SAVE FLAT ROCK GULLY AND MIDDLE HARBOUR

**RESPONSE TO EIS
PUBLIC CONSULTATION 9TH DECEMBER
2020- 1 MARCH 2021**

**BEACHES LINK AND GORE HILL EXTENSION
ENVIRONMENTAL IMPACT ASSESSMENT**

Figure 16-1 Regional Geological Context i.e.) uncertain or difficult geology which contributes to greater project risk

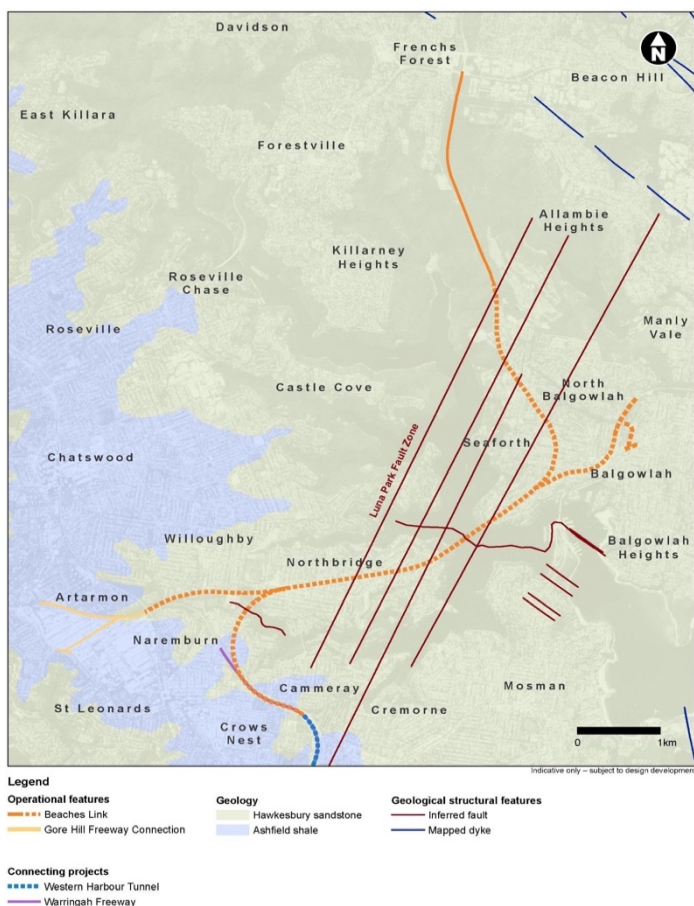
- Ensure the tunnel is fully lined to minimise drawdown
- Assess alternative routes that do not result in significant drawdown under homes and parks and cross uncertain geology

Figure 16-13 Groundwater drawdown contours for the project during operation in 2128 South of Middle Harbour

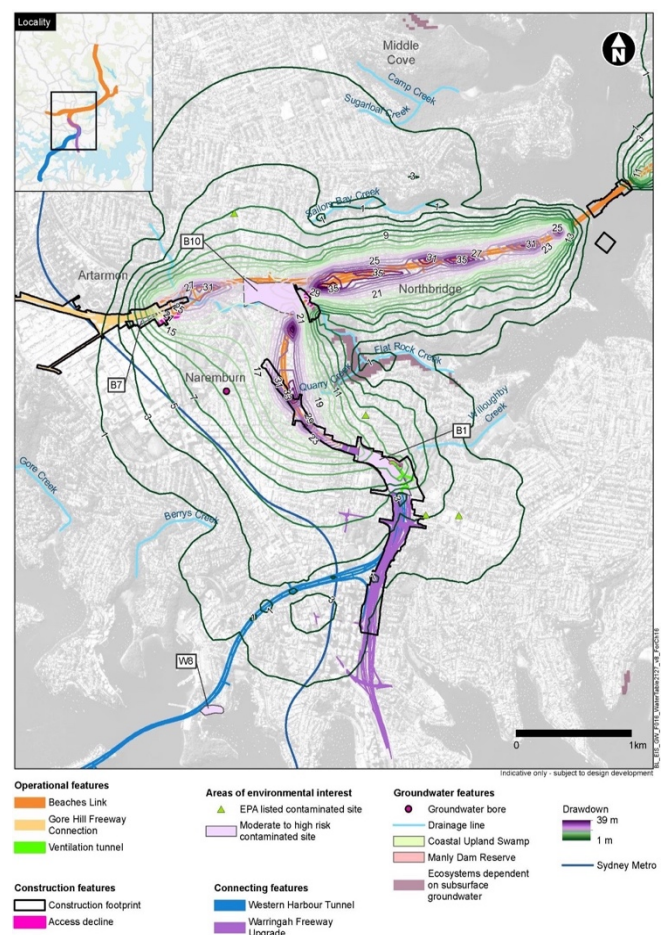
- Provide a pre-inspection survey for all homes and assets in the drawdown range (Fig 16-13) and provide rectification and/or compensation to owners and councils who experience damage to homes, buildings, bushland or sports fields.

Military Rd's traffic level the same or worse than today according to EIS

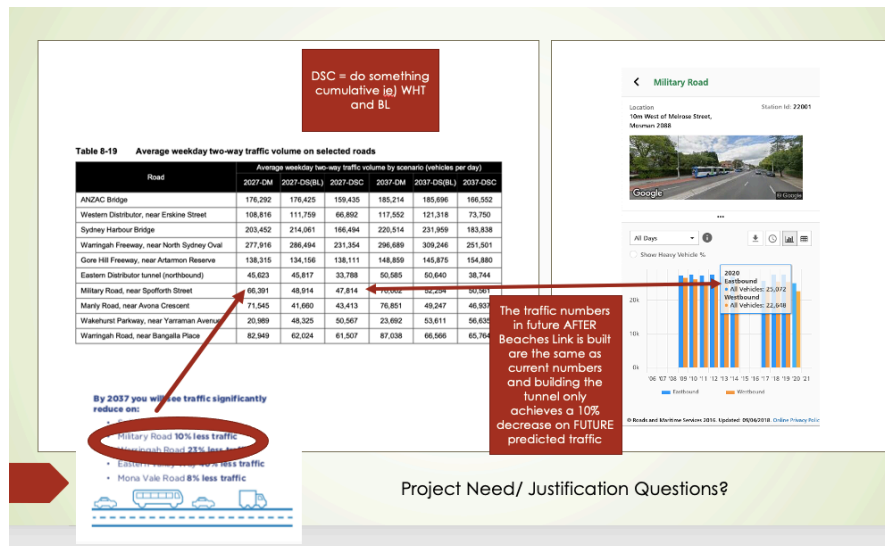
- **Does not address Military Rd congestion issue:** Once the Western Harbour and Beaches Link projects are built the EIS demonstrates that Military Rd will sit at roughly the same level of traffic as today (see diagram below) and be slightly worse ten years after opening. The project predicts a 10% reduction based on FUTURE predicted traffic volumes and not based on today's traffic numbers. The general public believe that the 10% figure is based on today's traffic and that the reduction will enable an urban renewal along the length of Military Rd – the promotion of this figure has been somewhat misleading. The assumptions included in modelled traffic growth are not made available in the EIS. The EIS states that the growth rate without the project by 2037 "is 13% into the Beaches and 12% along Military Rd". However, Appendix X, Table 8.2 indicates that there is a further 8.9% growth in peak hour traffic demand by 2037 above a future do nothing scenario across the Beaches Screenline if both tunnels proceed. This potentially represents a 20%+ growth in traffic for the Northern Beaches after the tunnels are built. It should be noted that a road that is already at capacity is self-limiting i.e.) future growth cannot overreach the ceiling capacity of the road and therefore a travel time saving, or reduction cannot be claimed on the basis of a figure above the ceiling capacity. Anecdotally Military Rd is reaching capacity however data for Military Rd with and without the project has not been provided. It is therefore impossible to verify the claim that a 10% reduction based on future increased volumes is possible. Further data should be provided to verify this claim and the public should be provided with clearer information on what the project can and cannot achieve compared to today's level of service along this corridor.
